ADDENDUM NUMBER 1

Dated: November 7, 2019

**MOSQUITO ROAD STABILIZATION PROJECT – PHASE 1
PROJECT NO. 41819
City of Placerville**

SHEET: 3 OF 10

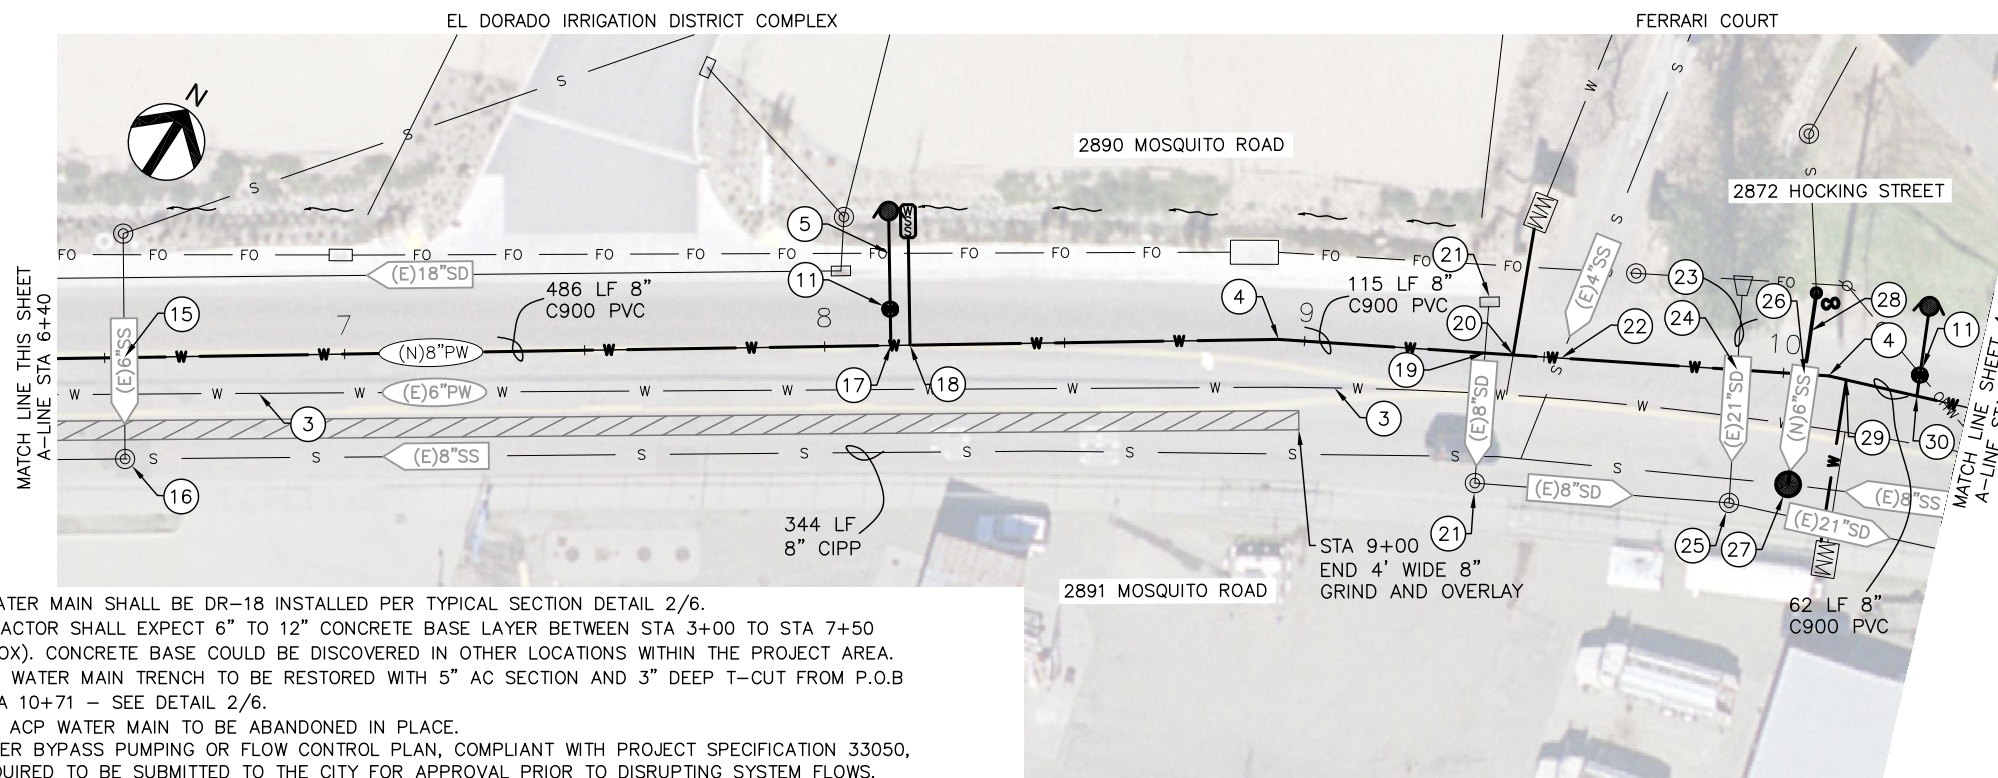
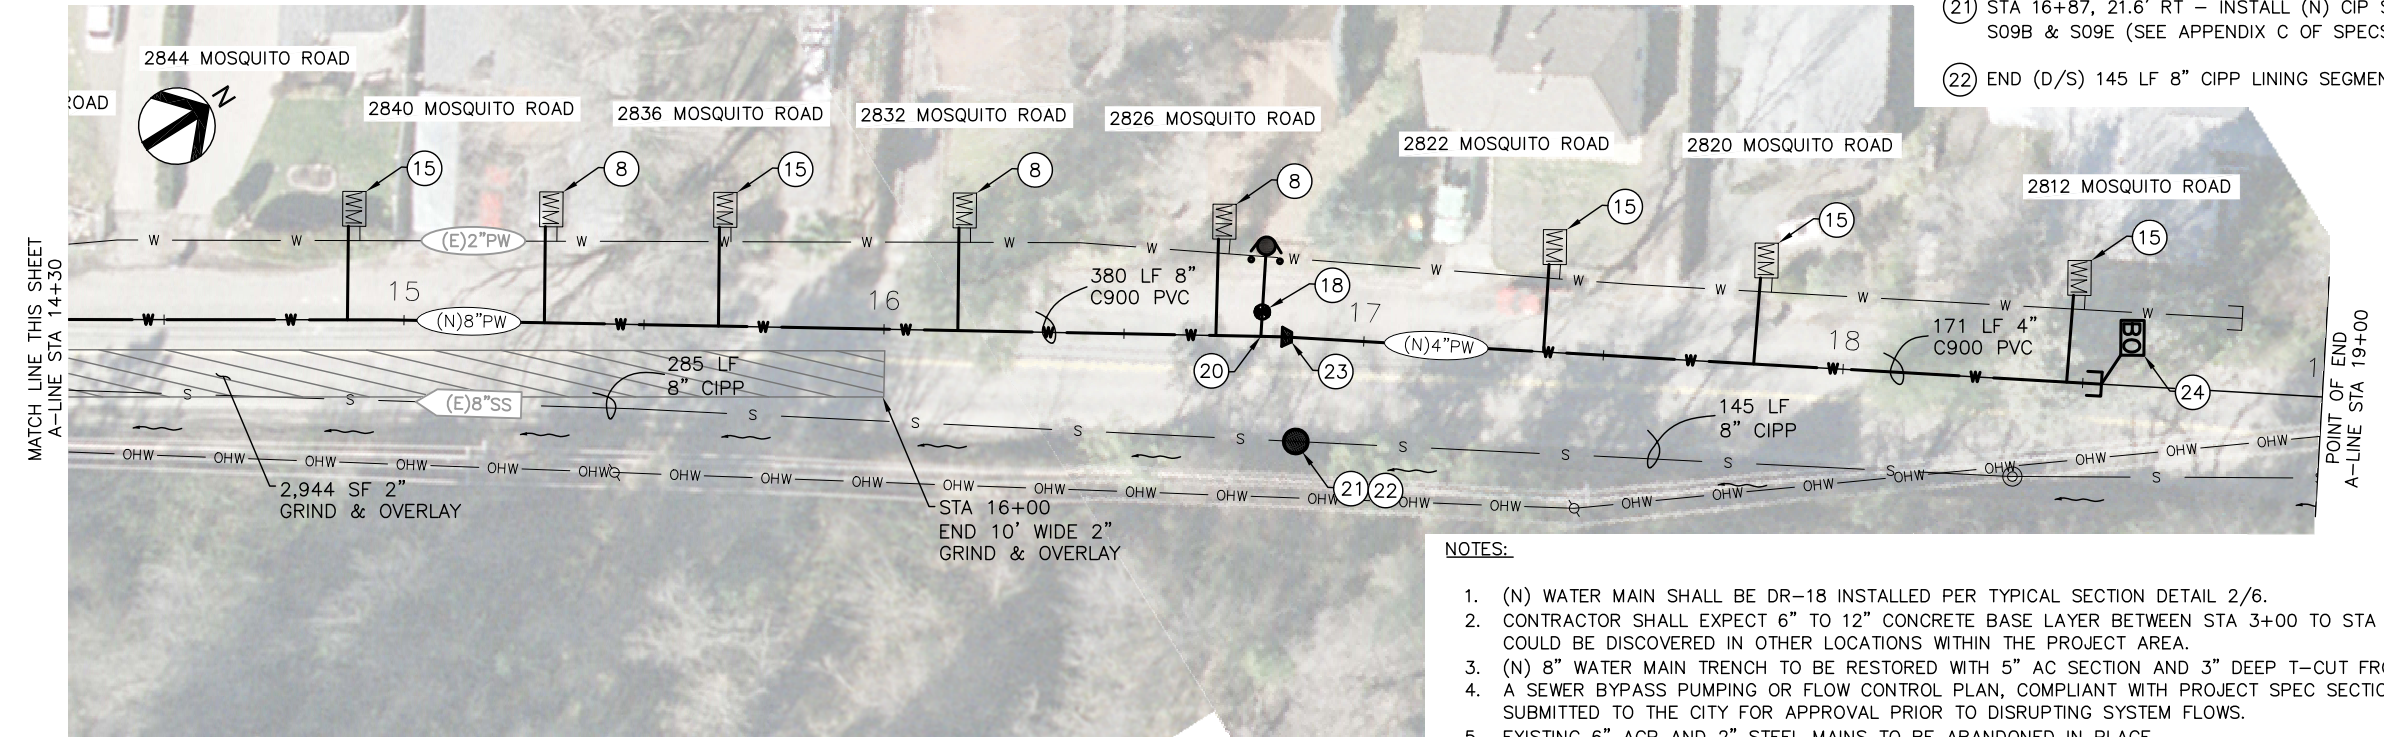
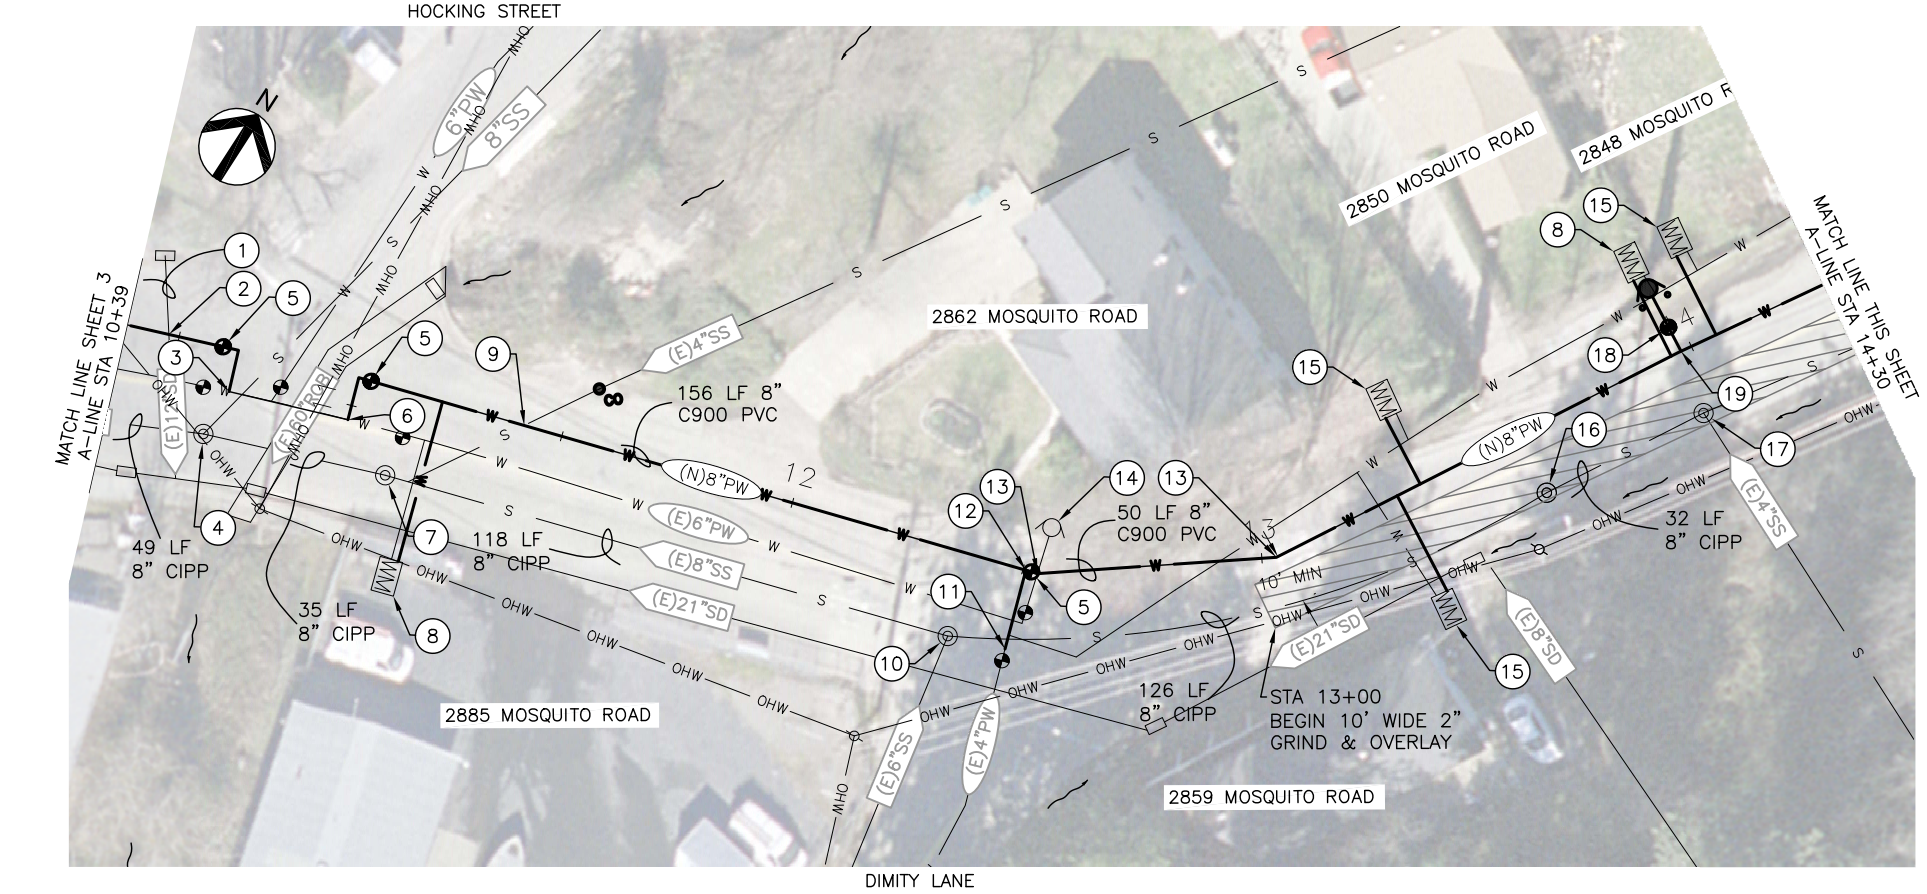
Regarding plan Sheet 3 of 10, "Water Main Replacement and Sewer Improvements", change existing water service line at A-Line STA 9+44 from thick (proposed) to thin (existing), and turn on layer containing proposed sewer manhole at A-Line STA 10+02, 23.1' RT.

SHEET: 5 OF 10
SCALE
HORZ: AS NOTED
VERT: AS NOTED

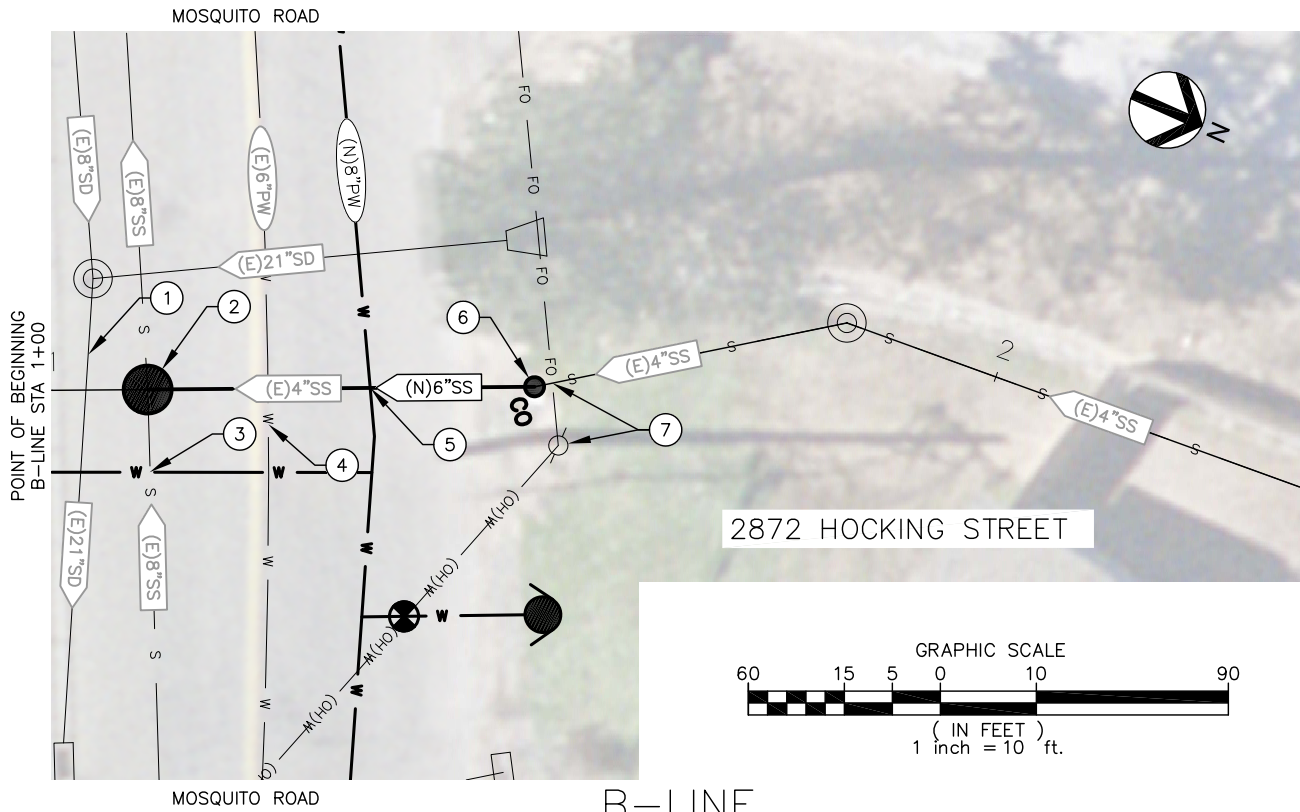
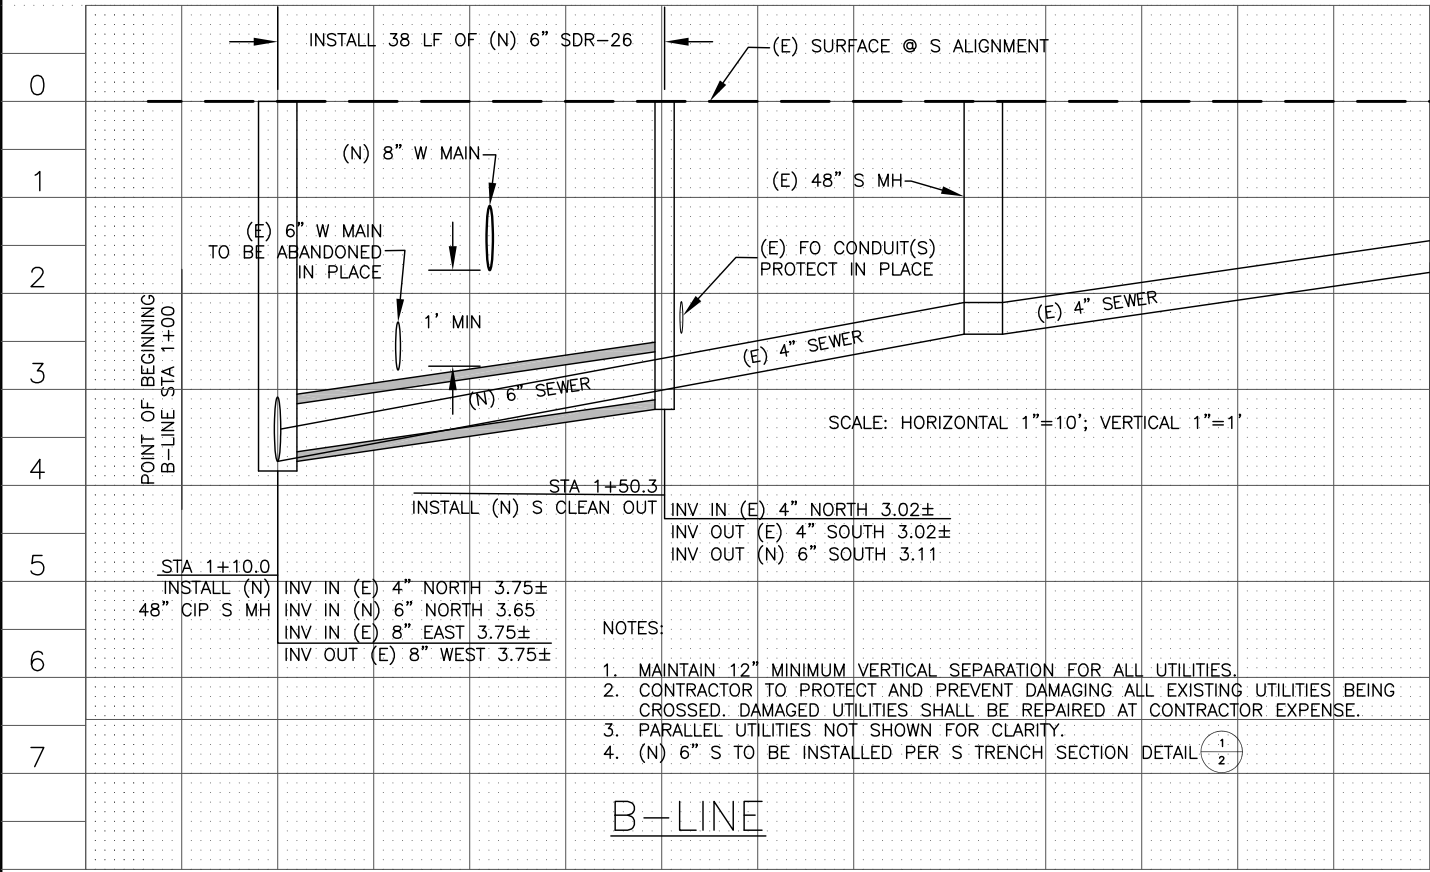
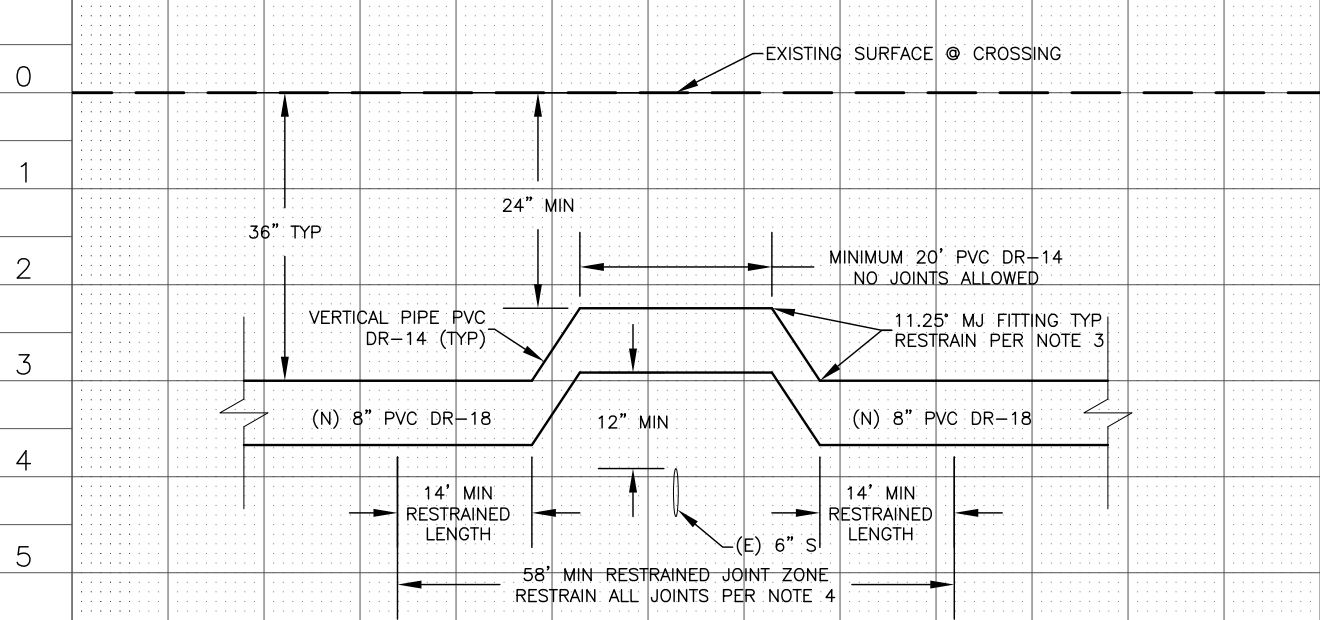
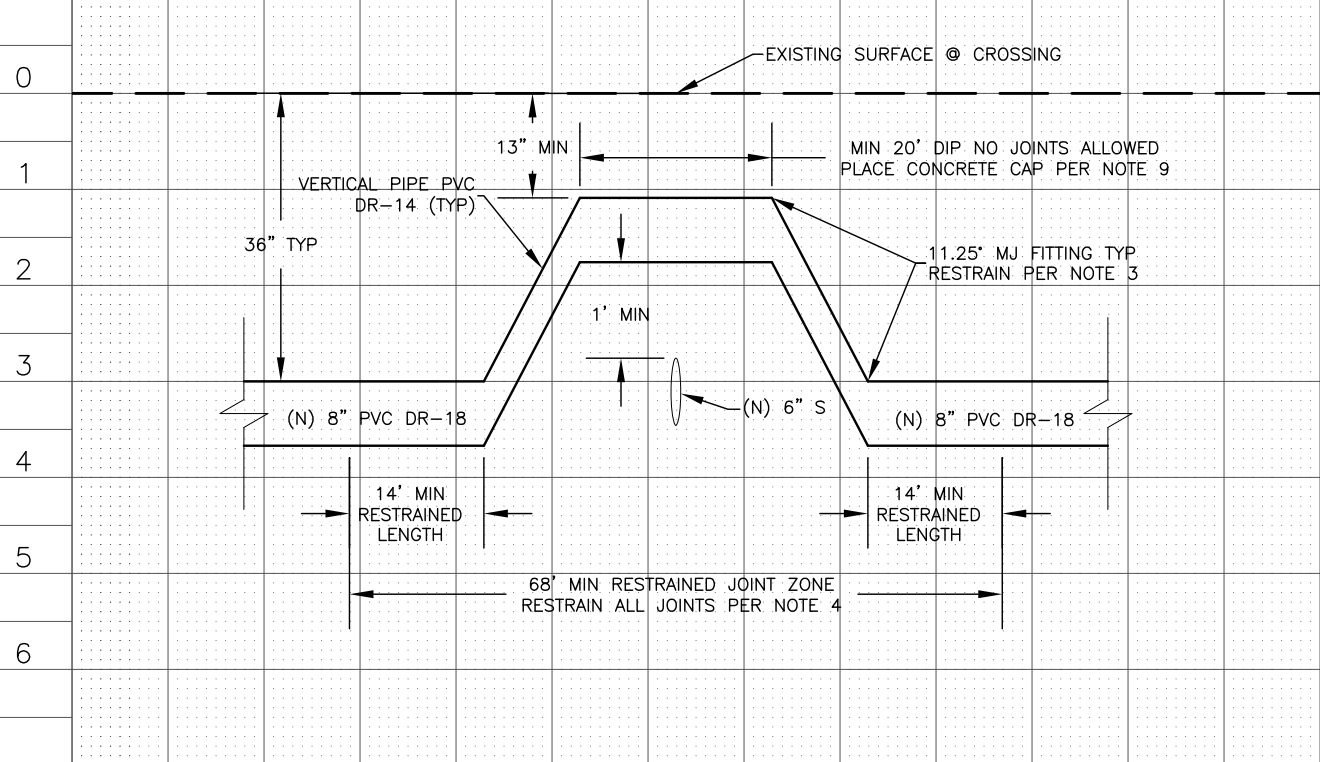
Regarding plan Sheet 5 of 10, “Sewer Main Replacement Sewer Water Main Crossing Profile Details”, change existing sewer cleanout symbol abbreviation from “CL” to “CO” at B-Line STA 1+50, and turn on layer containing new 1” water service at B-Line STA 1+33, 8.8’ RT.
